RE: Florida Power & Light/St. Lucie Unit 1 Final Compliance with EA-12-051 Order Modifying Licenses with Regard to Reliable Spent Fuel Pool Instrumentation

1. St. Lucie Plant, Unit 1 Order EA-12-051 Compliance Requirements Summary
2. St. Lucie Plant SFPI RAI Replies

**ST. LUCIE PLANT, UNTS 1 AND 2- INTERIM STAFF EVALUATION AND
REQUEST FOR ADDITIONAL INFORMATION REGARDING THE OVERALL
INTEGRATED PLAN FOR IMPLEMENTATION OF ORDER EA-12-051,
RELIABLE SPENT FUEL POOL INSTRUMENTATION**

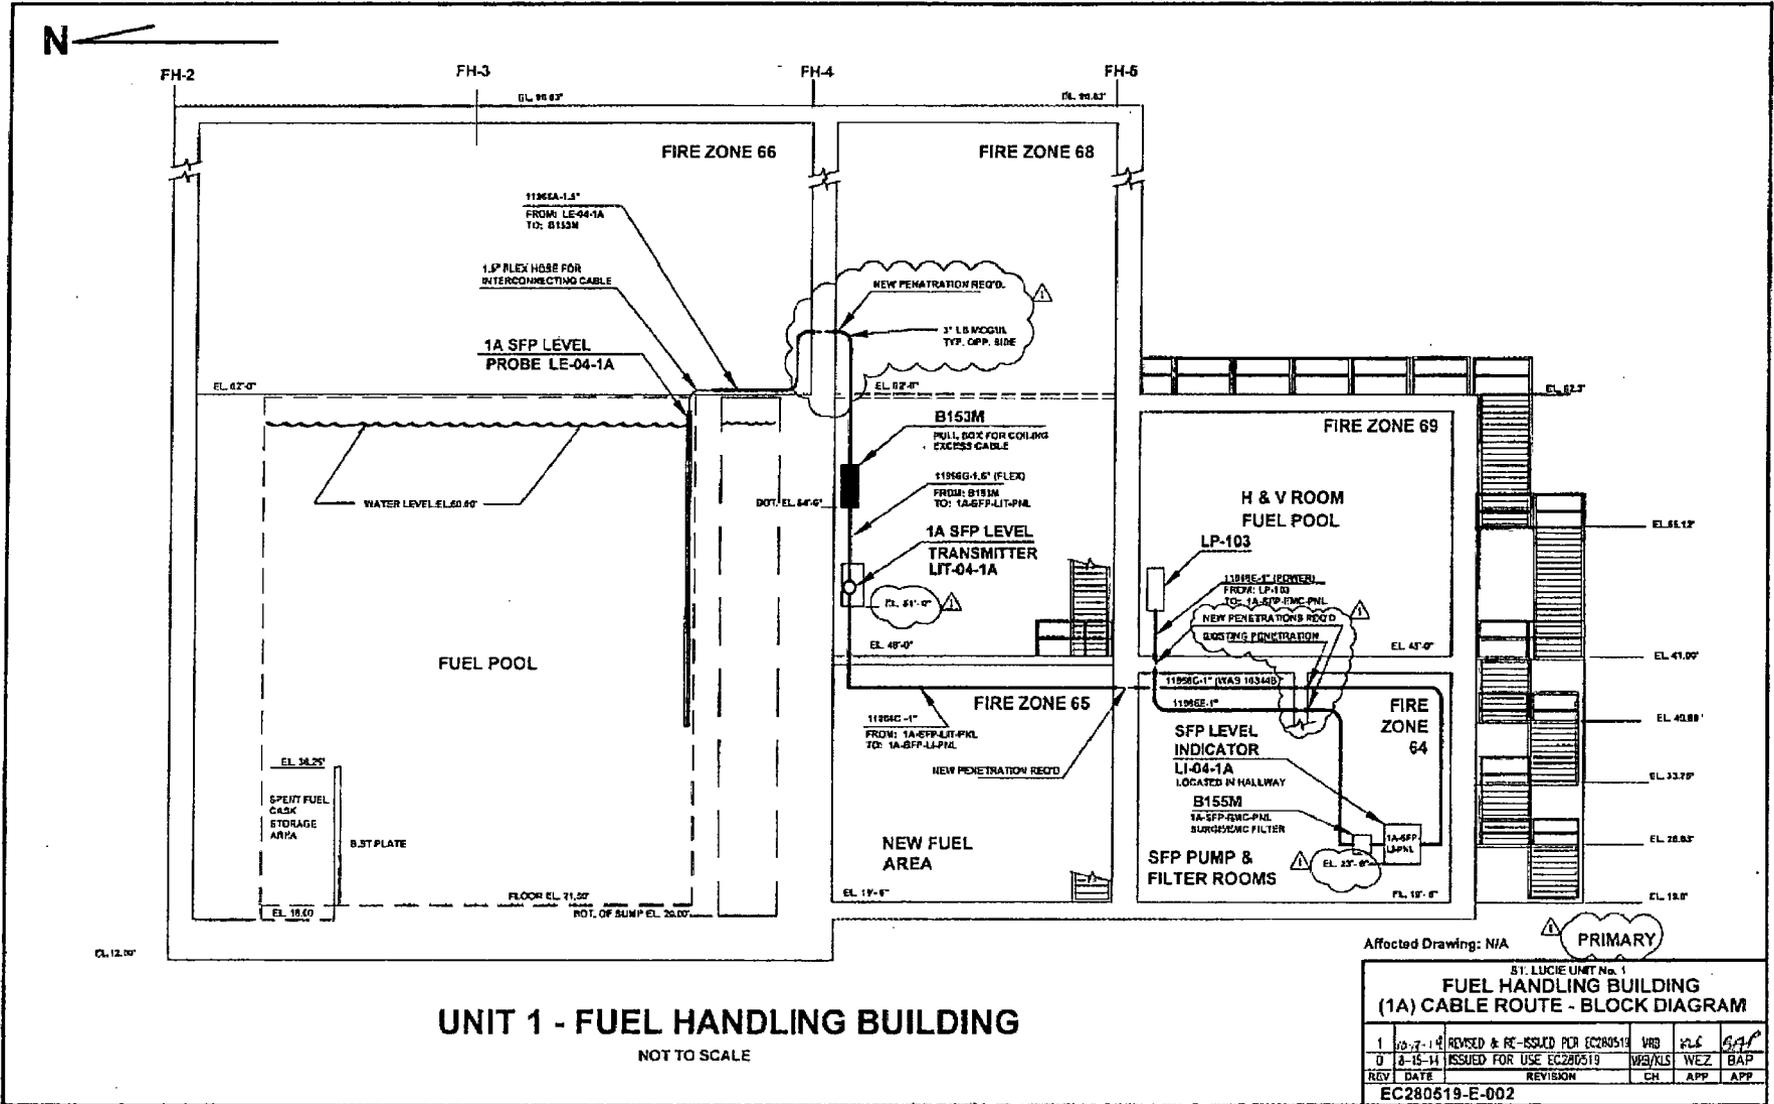
***Scenario 1 entails opening of the following doors:**

- Full-height door on the south wall of the spent fuel pool room
- Personnel door at the north end of the spent fuel pool
- Personnel door at the south end of the new fuel area (62' level) opening onto the H&V room roof
- Roll-up door on the east side of the new fuel area (19'-6" level)

***Scenario 2 entails opening of the following door:**

- Spent fuel pool room cask handling door
- Full-height door on the south wall of the Spent Fuel Pool room open (but not required per calculation).

ELAP FSGs invoke the configuration of Scenario 1.

CADD FILE: EC280519-E-002_1A SFP Level Instr.Block Dia.DWG

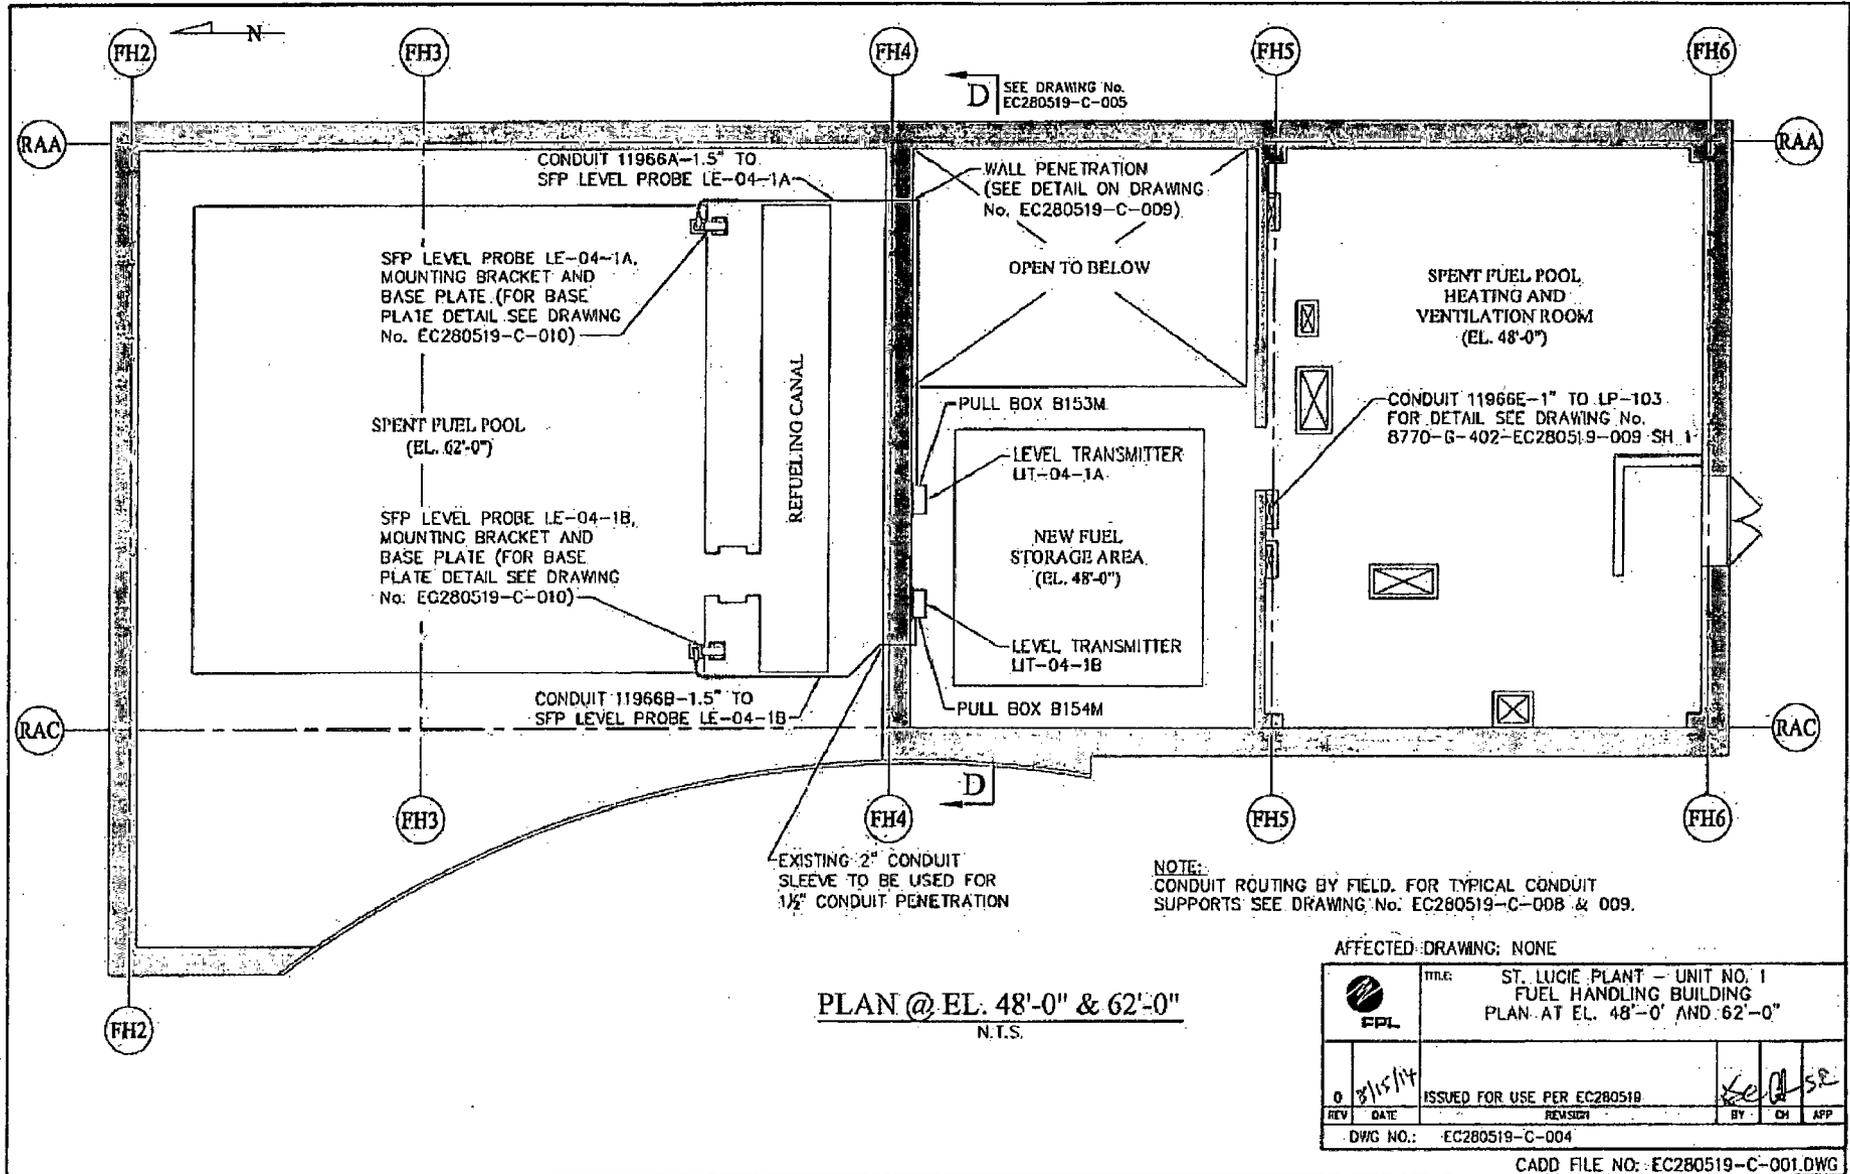
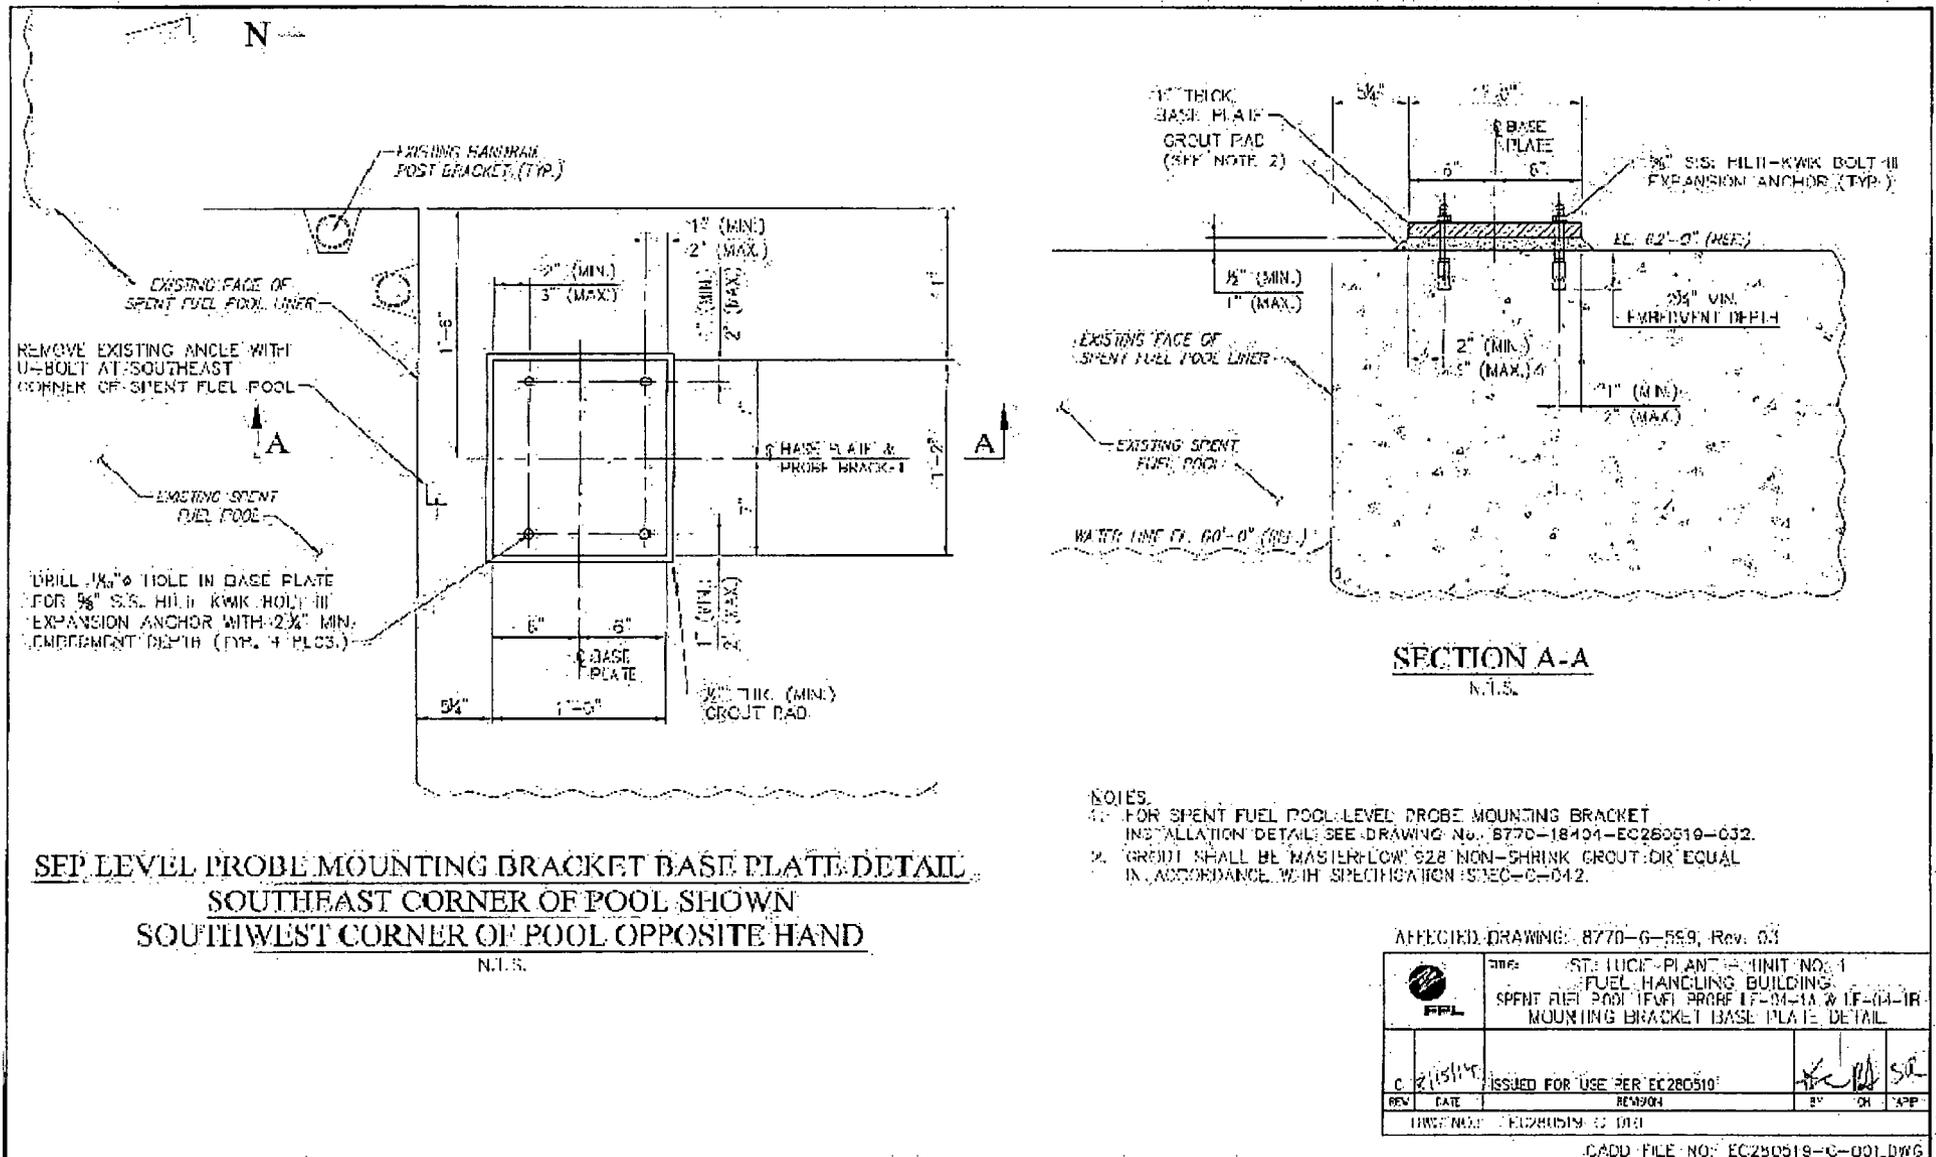
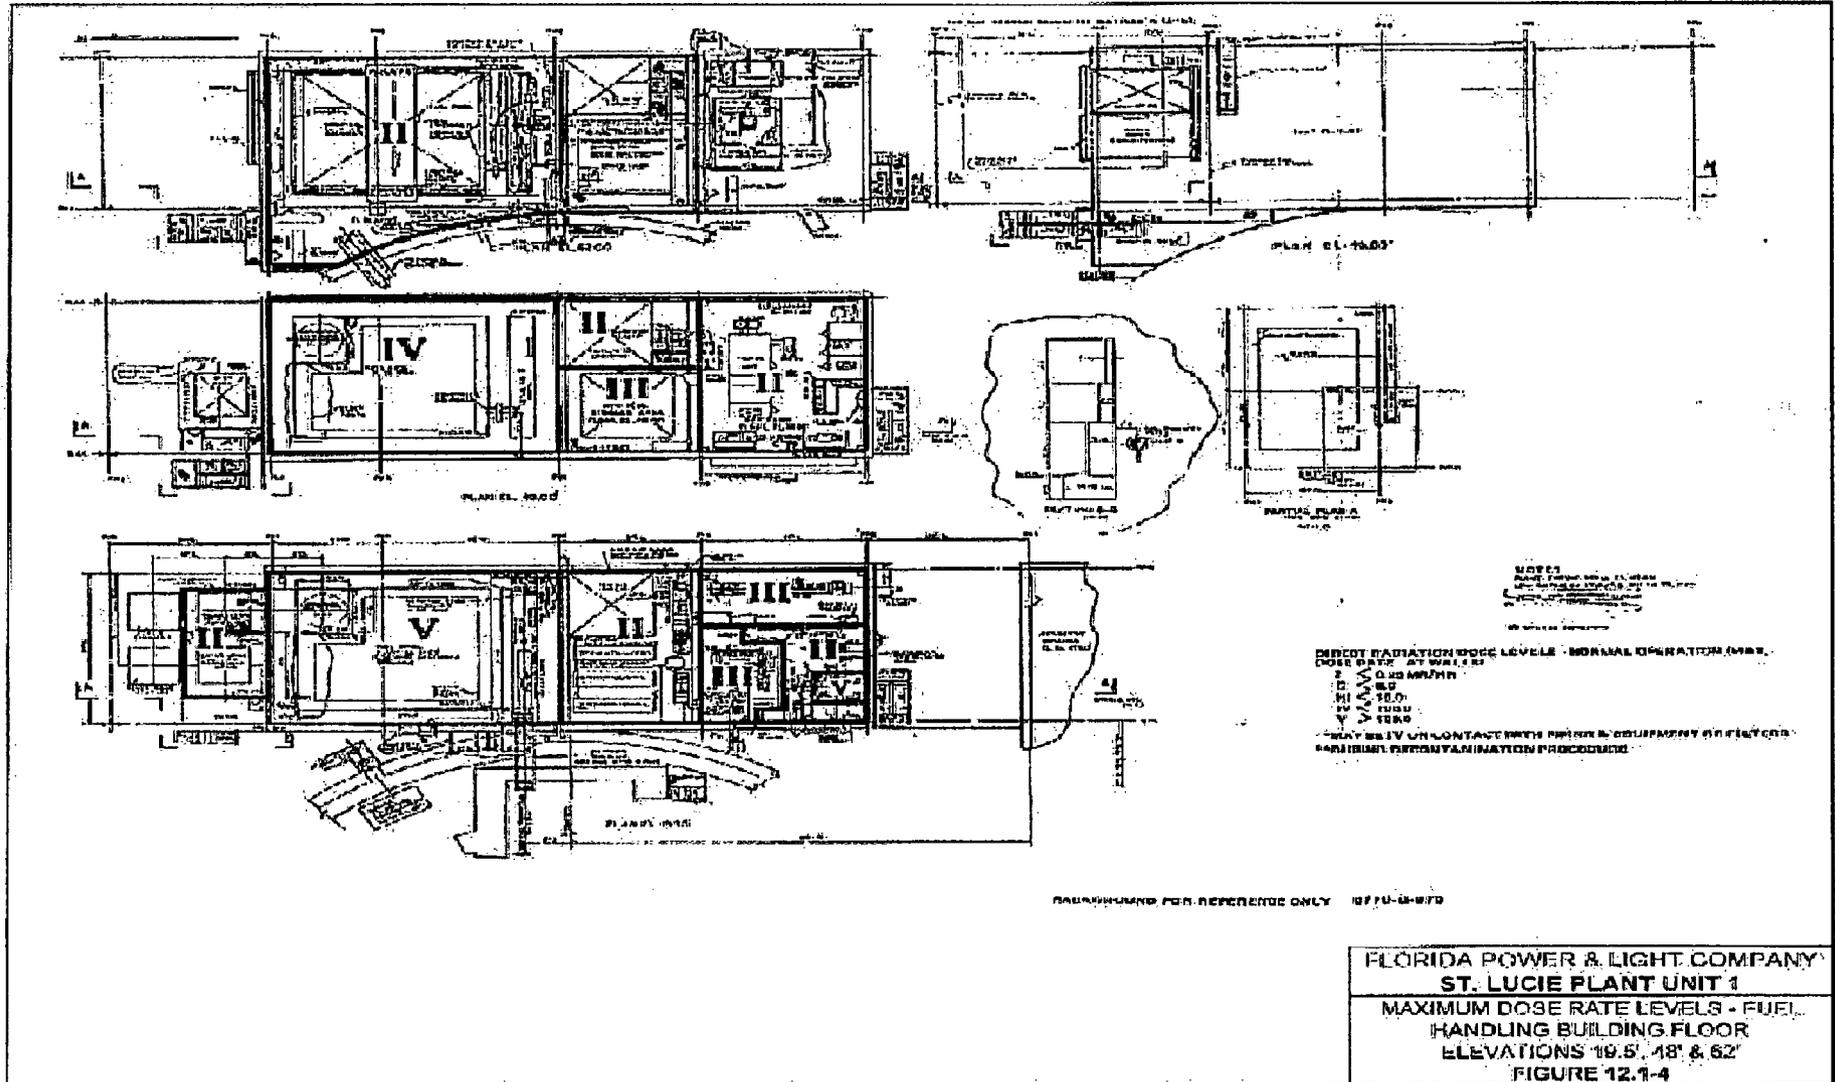
RAI #	RAI	Response
1	<p>Please provide additional information describing how the proposed arrangement of the SFP Guided Wave Radar sensing cables and routing of the instrumentation cabling between the SFP and final mounting location(s) of the monitoring read-out panels meets the Order requirements with respect to arrangement of the SFP level instrument channels in a manner that provides reasonable protection of the level indication function against missiles that may result from damage to the structure over the SFP.</p>	<p>The St. Lucie OIP was submitted to the NRC on February 28, 2013. In its OIP, the licensee stated that the primary instrument channel level sensing components will be located at the southeast wall of the SFP, and the backup instrument channel level sensing components will be located at the southwest wall of the SFP, approximately 33ft. from the primary instrument channel. Additionally, in its OIP, the licensee stated, in part, that the two SFP level instrument channels will be installed in diverse locations, arranged in a manner that provides reasonable protection of the level indication function against missiles that may result from damage to the structure over the SFP. Channel separation (independence) will be provided as part of the design of the SFP level instrumentation.</p> <p>SFP level sensor probes will be installed near the southeast and southwest walls of the SFP. Sensor conditioning electronics and battery backup will be located at the 48' elevation of the Fuel Handling Building. Level indication will be located at the 19'6" elevation of the Fuel Handling Building approximately 105 feet away from the SFP. The SFP and sensor conditioning electronics will be separated by a reinforced concrete wall(s) that will provide protection against missiles and will not interfere with SFP activities. Cabling for power supplies and indications for each channel will be routed in separate conduits for each channel.</p> <p>In addition, St. Lucie submitted a follow up letter dated August 28, 2013 that provided two sketches depicting the planned locations for the SFP level probes and the location of the level instrument components. A brief description of the method of maintaining physical separation between the primary and backup instrumentation channels was also included. Subsequent to those submittals, the NRC issued an Interim Staff Evaluation and request for additional information (RAIs) on November 19, 2013. After review of the St. Lucie OIP and the August follow up letter, the NRC staff concluded that the methodologies and guidance contained in the St. Lucie design appears to be consistent with the guidelines provided in NEI 12-02, Revision 1; However, the staff requested final cable routing drawings to confirm the independence of the two SFP level instruments.</p> <p>Therefore, as part of this submittal St. Lucie is providing final design drawings (Attachment 2) that illustrates the instrumentation mounting locations as well as the conduit routing.</p>
